ADDENDUM NO. 2

**Coventry Township
NEW FIELD HOUSE
Logan Field
2701 North turkeyfoot Road
Akron, Ohio 44319**

**Prepared by
Four Points Architectural Services, Inc.**

April 29, 2024

FIRST FLOOR PLAN

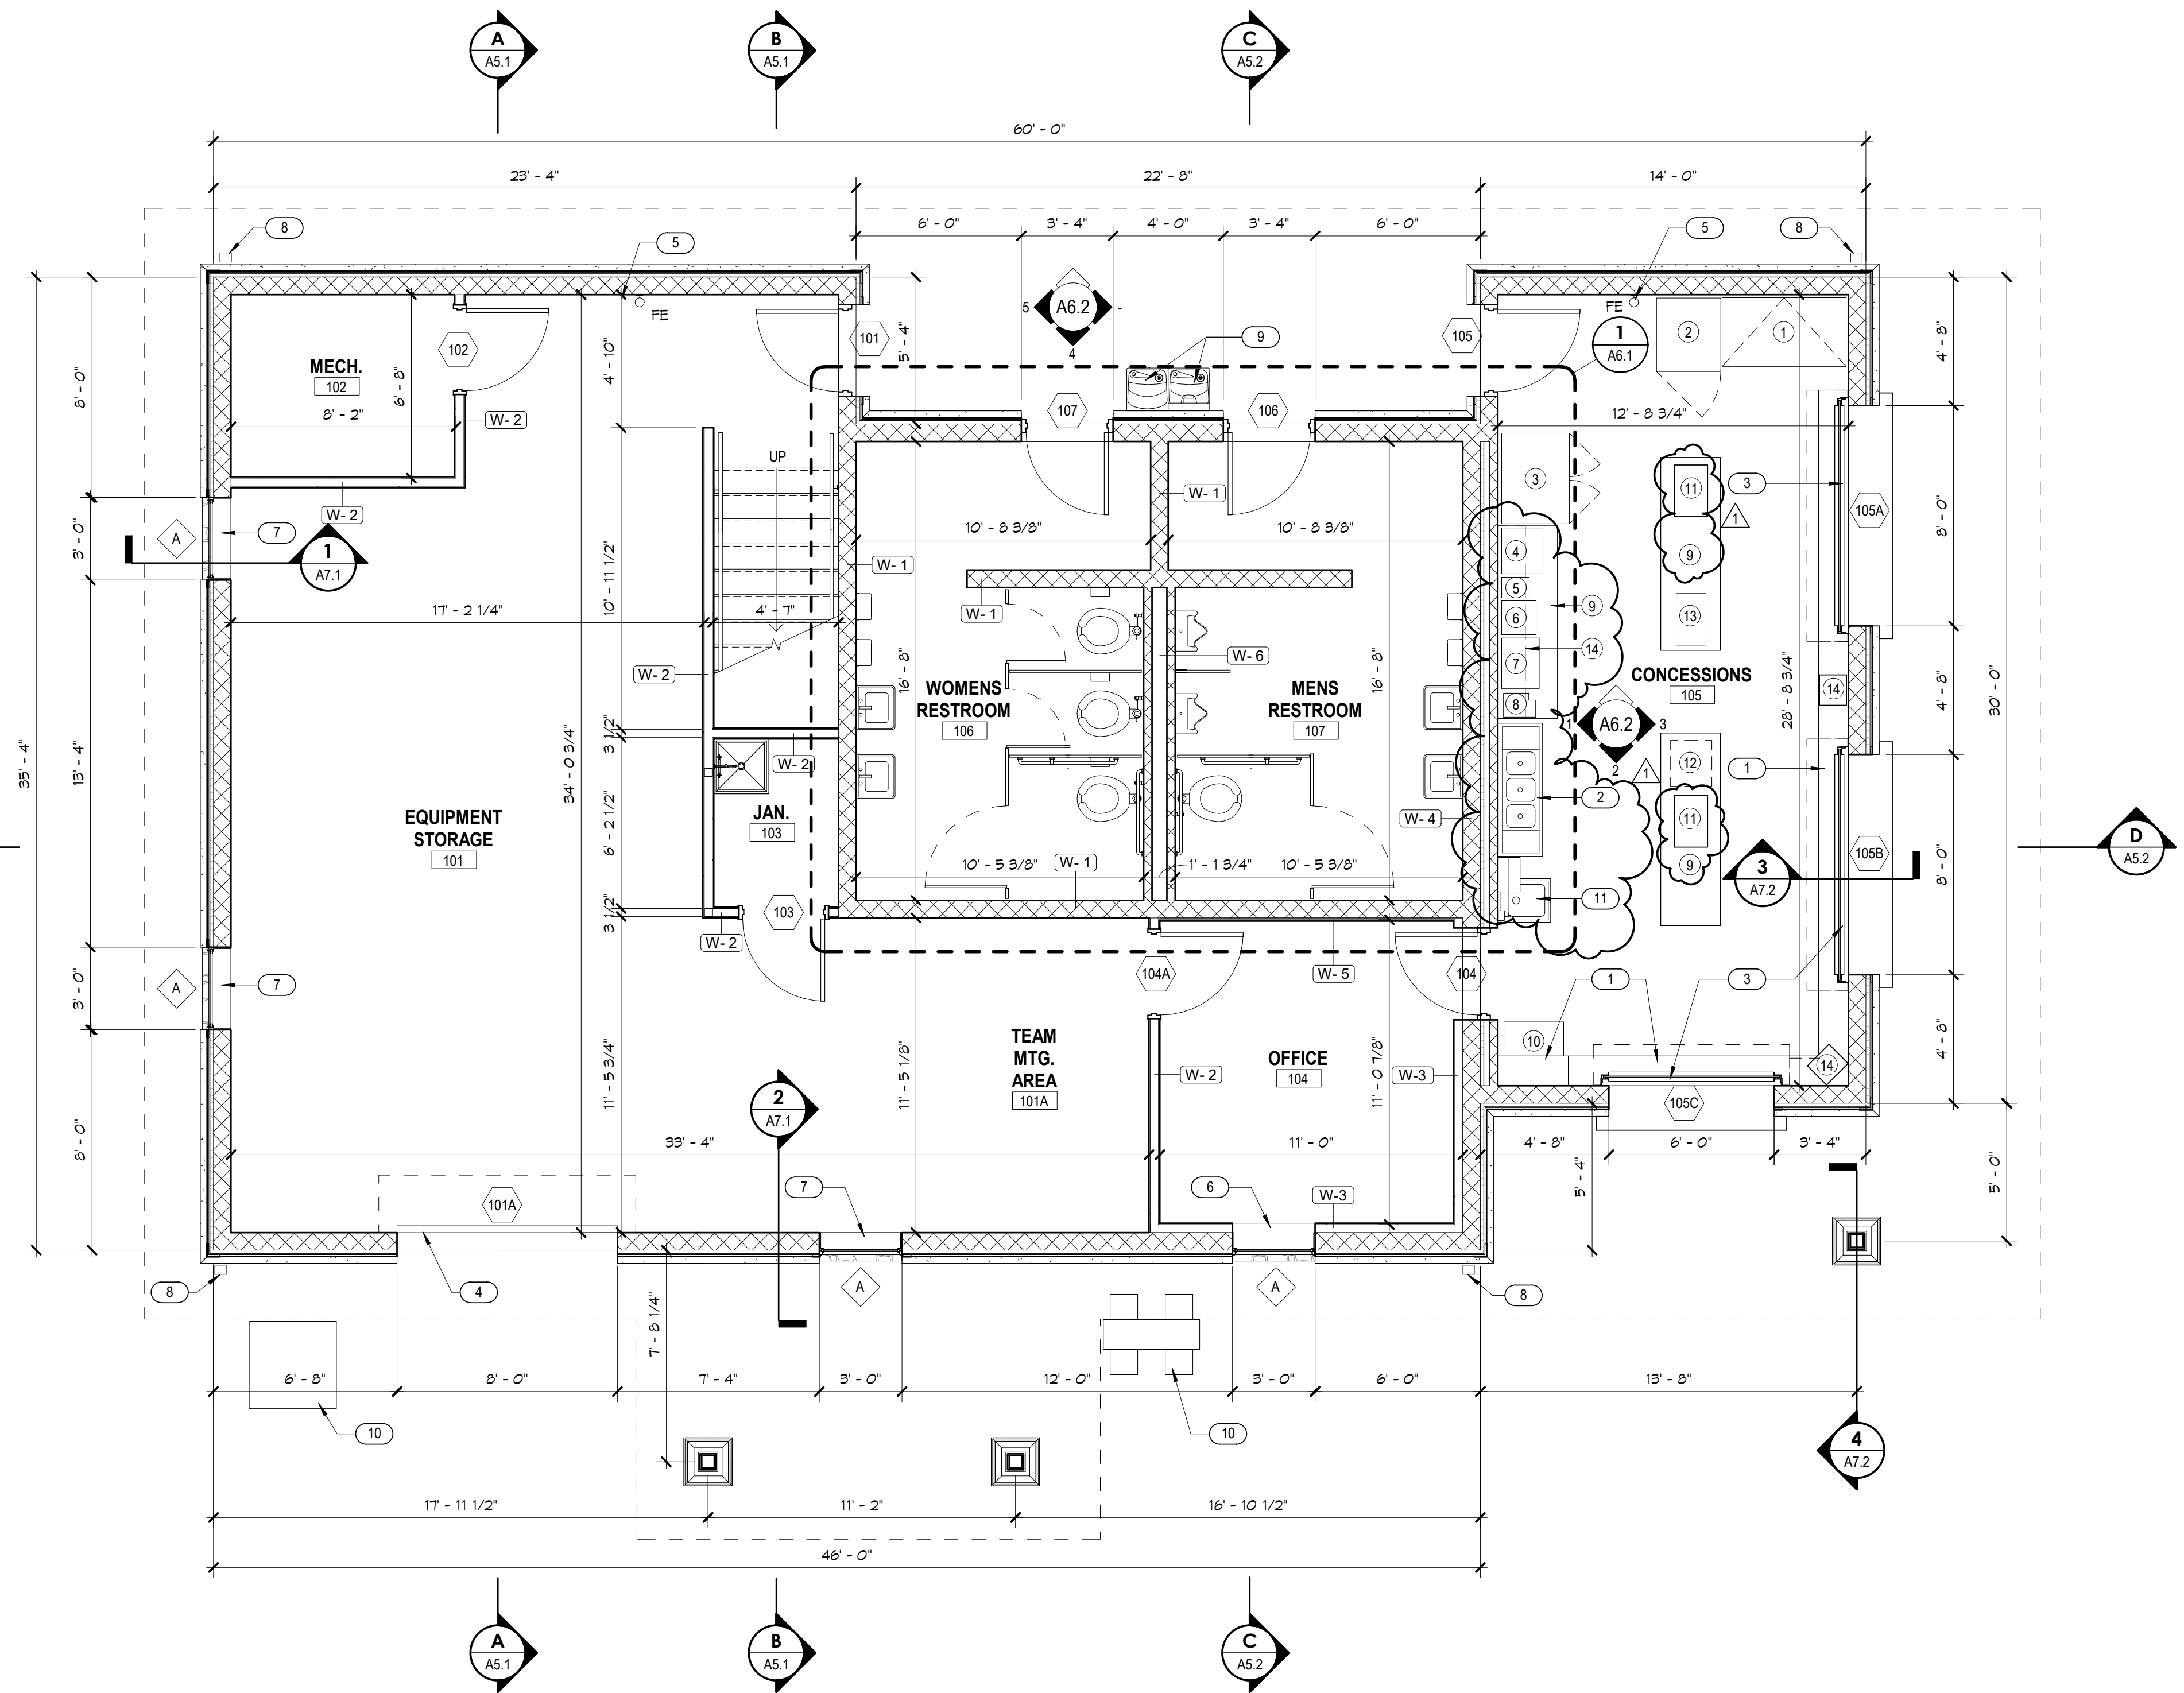
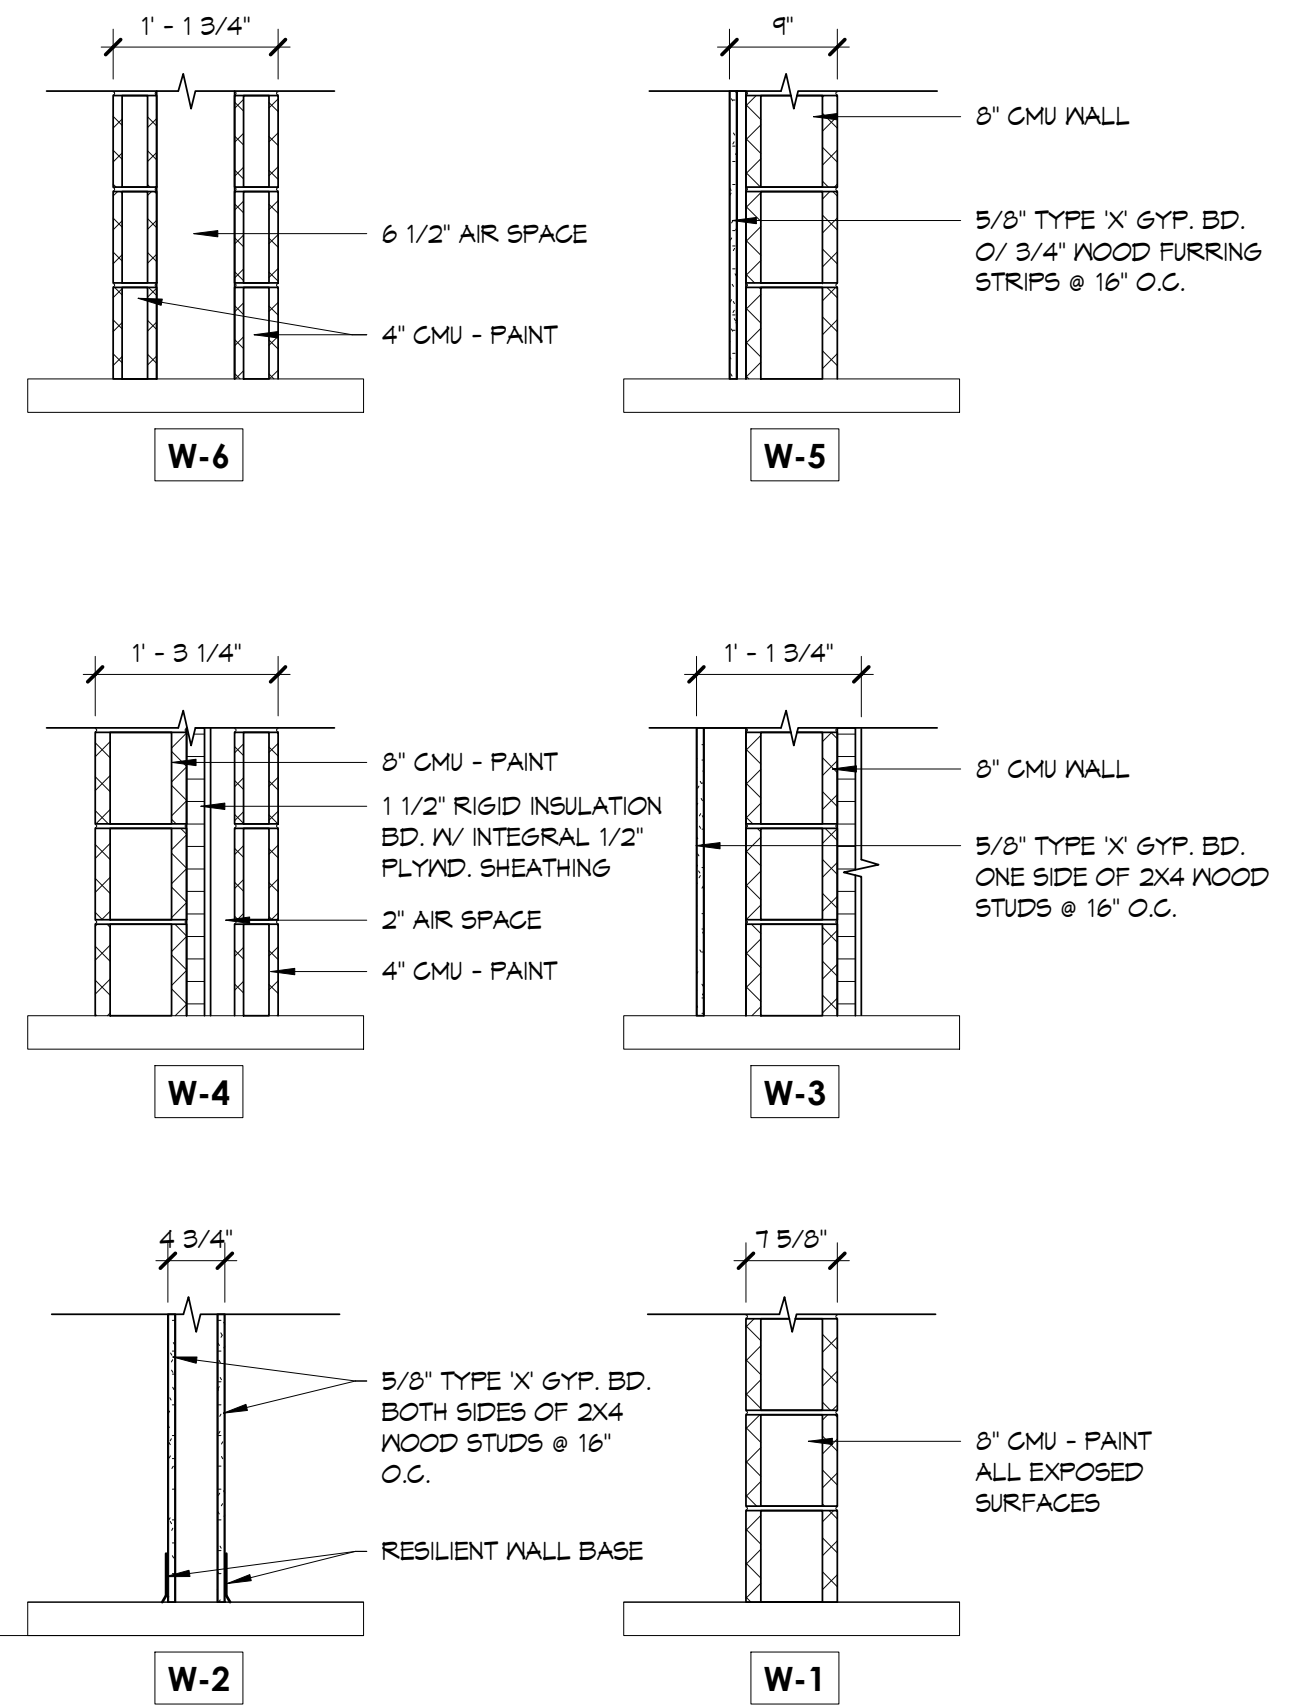
- a. The equipment layout shown in the concession stand has been revised.

1
ROOF PLAN
A3.1 1/4" = 1'-0"

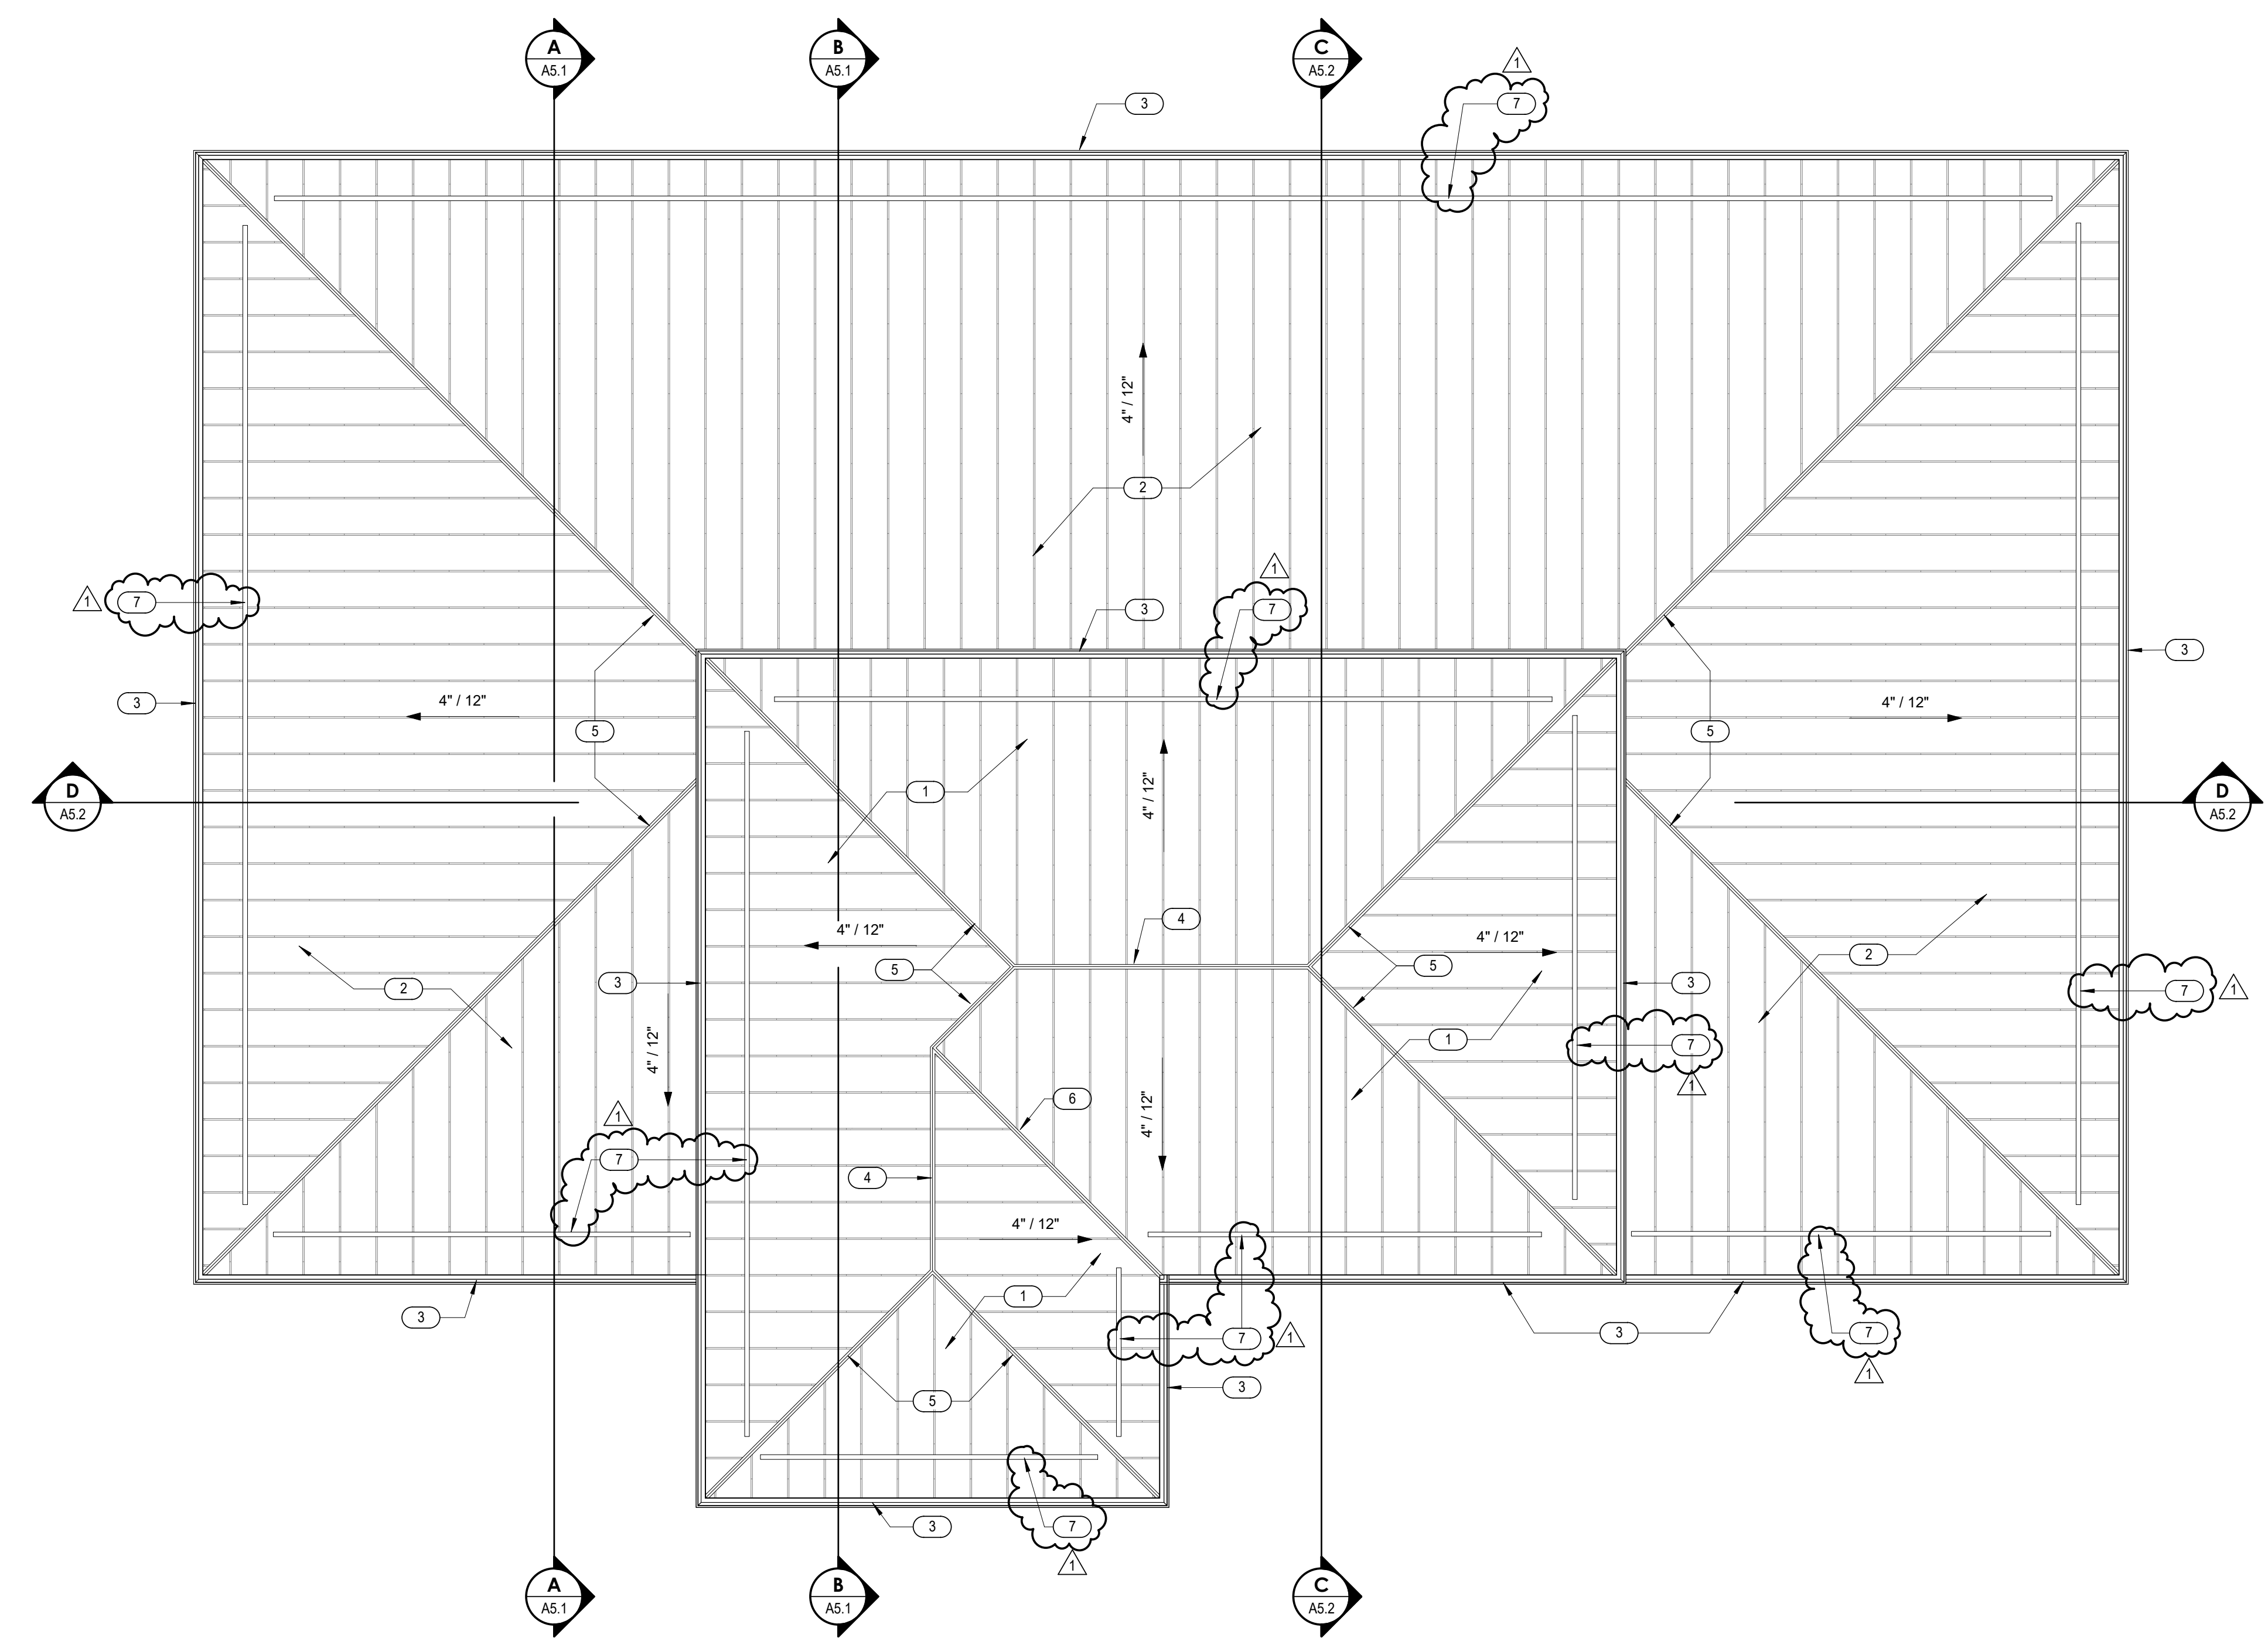
3. **Sheet A3.1 – Roof Plan:**

- a. Locations of snow guard rails have been shown and noted on the Roof Plan.
